King County

PRELIMINARY REPORT TO THE CITY OF KIRKLAND PUBLIC HEARING TO BE DETERMINED BY THE CITY

PROPOSED PLAT OF JUANITA TOWNHOMES FILE NO: PLAT13-0001

ATTACHMENT 1
PAGE 1 OF 2
PAGE 2

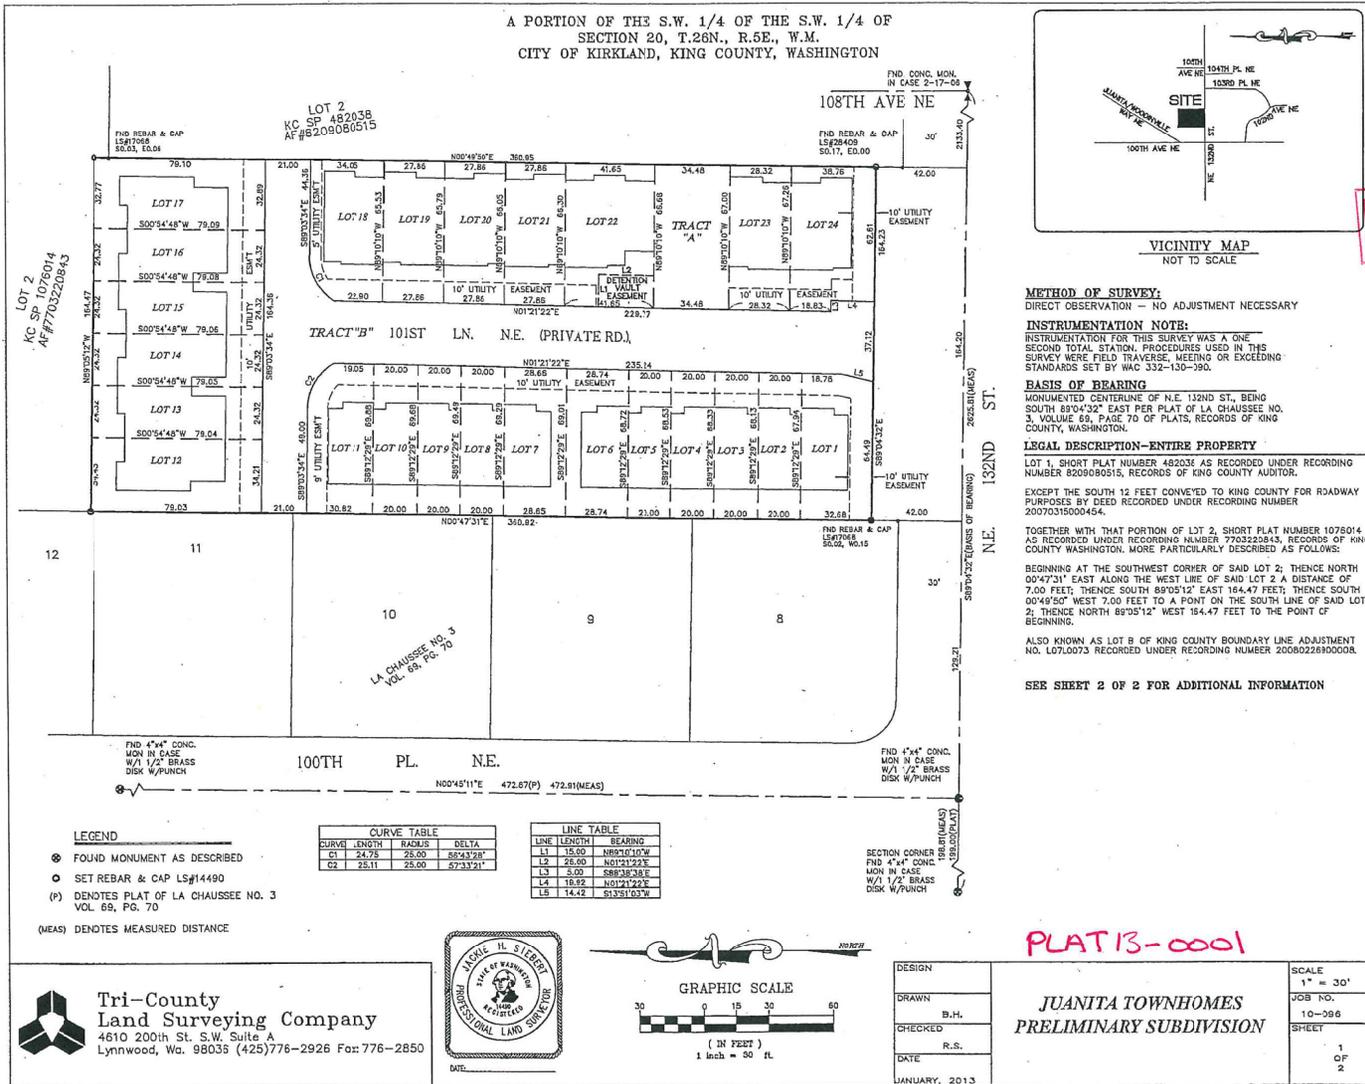
This is a request to void the previously recorded Binding Site Plan (BSP) and replace it with a subdivision of the 1.39- acre site, zoned R-24 into 24 subdivided lots for attached single-family dwellings. The lot size ranges from approximately 1,361 to 2,511 square feet. See Attachment 1 for a copy of the proposed site plan. The road, drainage facility and dwellings have been constructed.
